MICROCHIP PIC18F2515/2610/4515/4610

PIC18F2515/2610/4515/4610 Rev. A3 Silicon Errata

The following silicon errata apply only to PIC18F2515/2610/4515/4610 devices with these Device/Revision IDs:

FIGURE 1: SCK PULSE VARIATION USING TIMER2/2

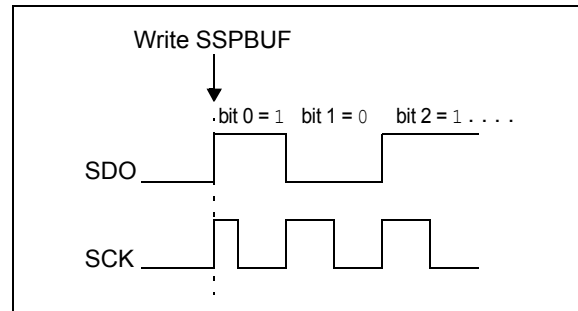
33. Module: MSSP (SPI Mode)

When the SPI is using Timer2/2 as the clock source, a shorter than expected SCK pulse may occur on the first bit of the transmitted/received data (Figure 1).

Work around

To avoid producing the short pulse, turn off Timer2 and clear the TMR2 register, load the SSPBUF with the data to transmit and then turn Timer2 back on. Refer to Example 5 for sample code.
